PRODUCT/PROCESS CHANGE NOTIFICATION

PCN IPG-IPC/14/8322
Dated 10 Feb 2014

**Qualification of a new HD lead frame and new resin
SUMITOMO G630AY for SO 8 package in ST Bouskoura (Morocco)**

Fig1: Current SO8 LF (5x3x8=120 units /strip; 57.7x215.7 mm)

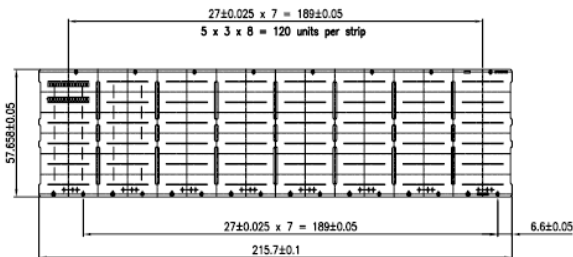
This report contains all the reliability activities in order to evaluate the new HD lead frame (320 units/strip vs 120 units/strip) used for the assembly of SO8 package in BOUSKOURA (Morocco) assy plant. With respect the current pre-plated lead frame, the new HD LF is a Cu - Ag spot lead frame; a pure tin lead plating process step will be introduced in the process flow after post mold curing step and before cropping.
